Access Compliance Report

Public Rights-of-Way

(Curb Ramps)

Intersection ID: 47123	Main Street: THOMPSON_BROOK_LN	Cross Street: EMMONS_LN	Location: SW
ADA ID: 21EF3C9480EE	Ramp Type: PerpDiag	Initial Pass/Fail: Fail	Overall Compliance: No
Severity Score: 8.75			
Codes/Mitigation Info/Possible Solution		Field Measurements/Component Compliance

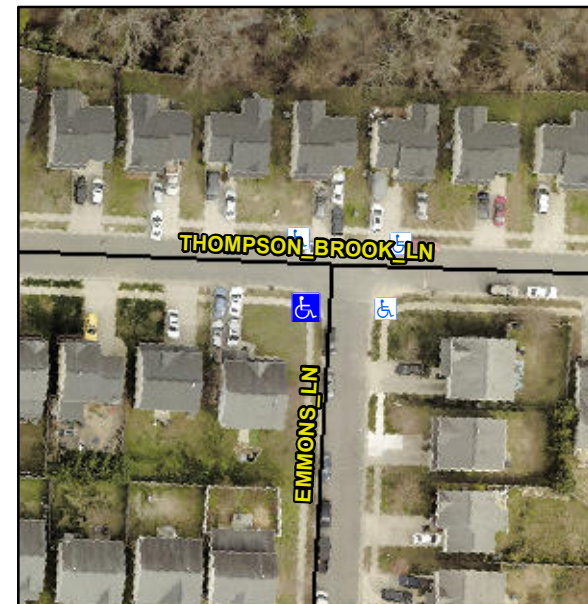
Not Found, R304.5.1

Compliance	Description	Data	Compliance	Description	Data
N/A	Ramp Length (in)	45.0	Yes	Ramp Slope (%)	5.3
No	Ramp Width (in)	44.0	Yes	Ramp XSlope (%)	1.9
N/A	Flare Type LT	N/A	N/A	Flare Type RT	N/A
N/A	Flare Slope LT (%)	N/A	N/A	Flare Slope RT (%)	N/A
N/A	Flare Traversable LT?	N/A	N/A	Flare Traversable RT?	N/A
N/A	Landing Length (in)	N/A	N/A	DWS Provided?	N/A
N/A	Landing Width (in)	N/A	N/A	DWS Contrast?	N/A
N/A	Landing Slope (%)	N/A	N/A	DWS Length (in)	N/A
N/A	Landing X Slope (%)	N/A	N/A	DWS Full Width?	N/A
N/A	Landing Curb? (Y/N)	N/A	N/A	DWS Offset (in)	N/A
N/A	Shared Landing?	N/A			
N/A	Gutter Ponding?	N/A	N/A	Gutter Slope (%)	N/A
N/A	Gutter Lip Ht (in)	N/A	N/A	Gutter X Slope (%)	N/A
N/A	Painted X Walk1?	No	N/A	Painted X Walk2?	No
	X Walk 1 Direction	To SE		X Walk 2 Direction	To NE
N/A	X Walk 1 Width (in)	N/A	N/A	X Walk 2 Width (in)	N/A
	X Walk 1 Slope (%)	2.3		X Walk 2 Slope (%)	1.1
	X Walk 1 X Slope (%)	0.5		X Walk 2 X Slope (%)	0.8

Remove & Replace Curb Ramp With Two New Directional Ramps or Equivalent.
